January 17, 1986
JVM-86-010

Subject: Transmittal of Information in Support of Topical
Report NUH-001

PROJECT NUHOMS GENERIC DESIGN

Fig 4.4
Max Concrete Temp vs Year Discharge
(70° Ambient)

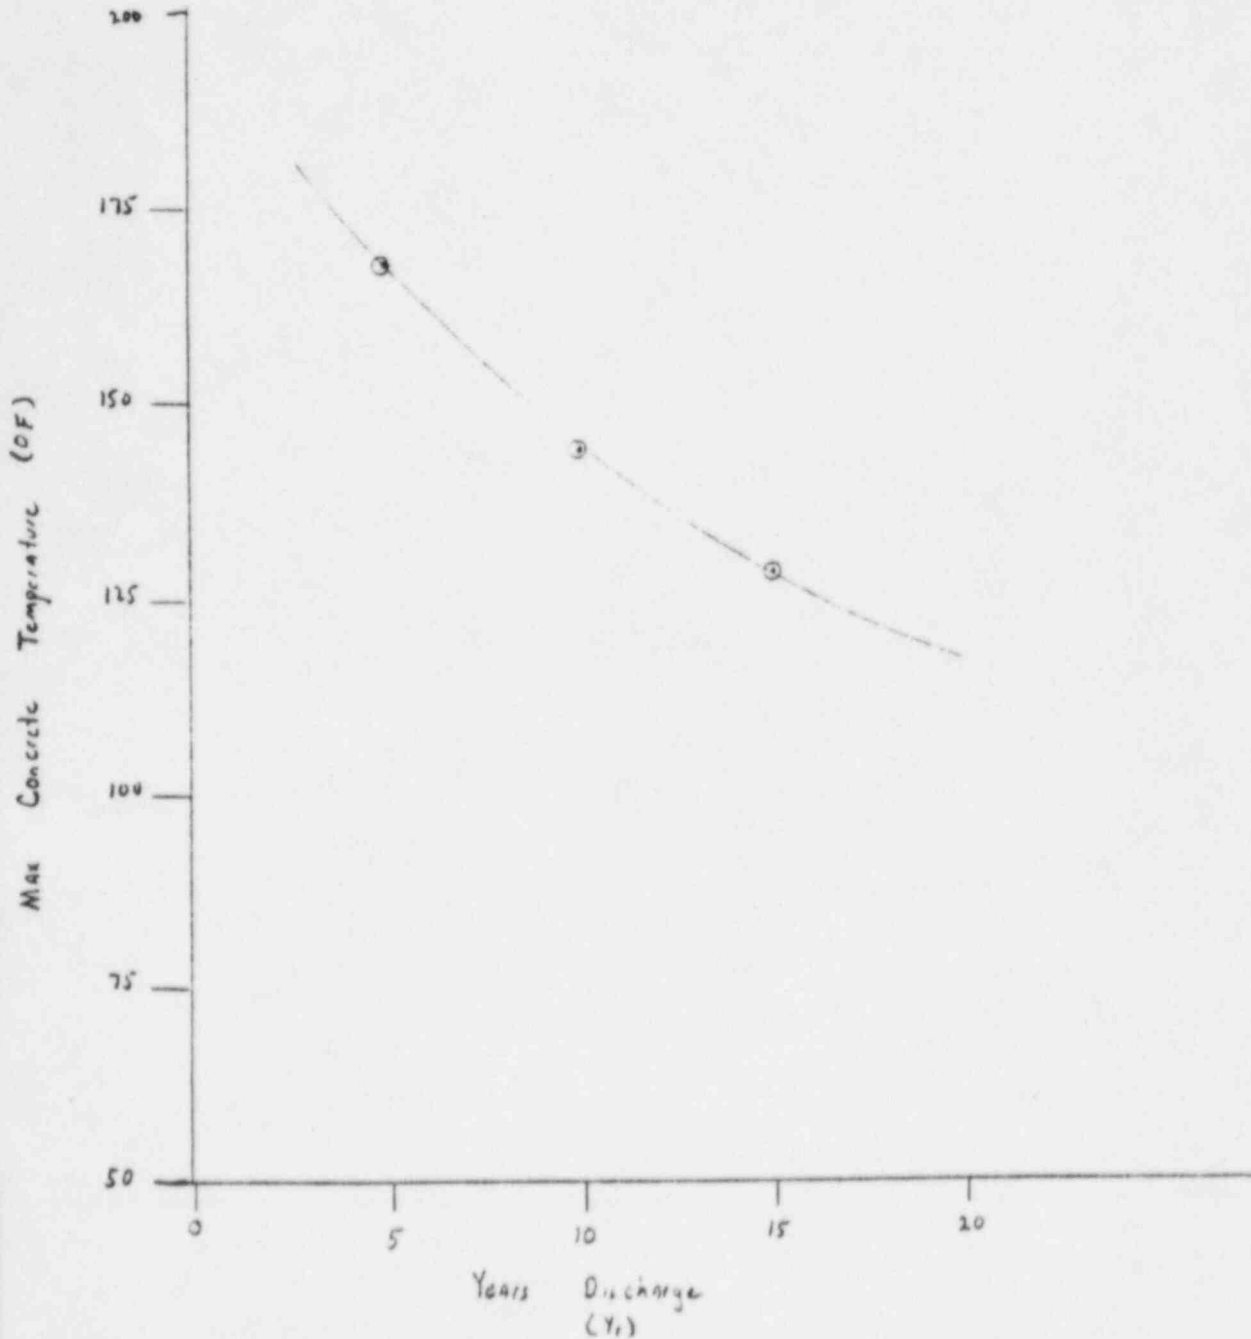
The 15 months, until code temperatures are met for 100°F ambient conditions, referred to on page 8.1-48 comes from a concrete temperature decay of approximately 5.5°F/year and assuming the maximum temperature to be 207°F (this is the expected maximum temperature if the air is always 100°F and the module outer surface is cycled through 12 hours of solar heat flux and 12 hours of no solar heat flux). If the most conservative maximum temperature, 214°F (100°F ambient temperature with infinitely long solar heat flux), were used, it would take slightly over 30 months before the maximum concrete temperature would be below 200°F.
